# Access Compliance Report

## Public Rights-of-Way

### (Curb Ramps)

Intersection ID: 32118	Main Street: COLE_MILL_RD	Cross Street: DUNDALK_RD	Location: W
ADA ID: 705880D66D02	Ramp Type: PerpDiag	Initial Pass/Fail: Fail	Overall Compliance: No
Severity Score: 10			
Codes/Mitigation Info/Possible Solution		Field Measurements/Component Compliance

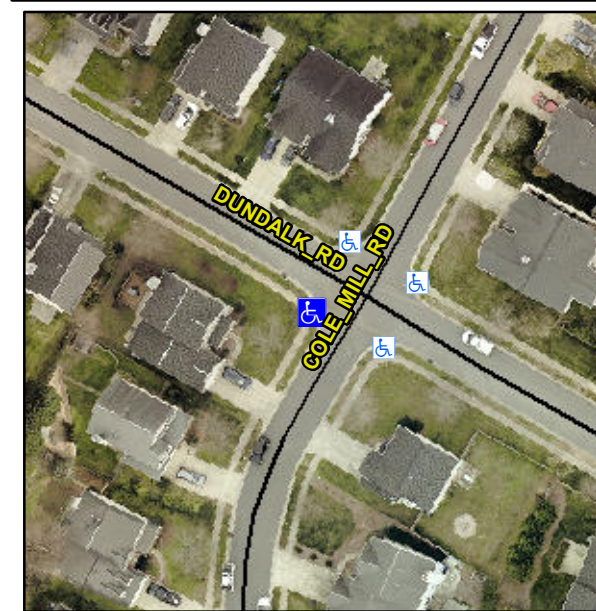
**Remove & Replace Curb Ramp With Two New Directional Ramps or Equivalent.**

**Not Found, R304.5.1, R304.5.3**
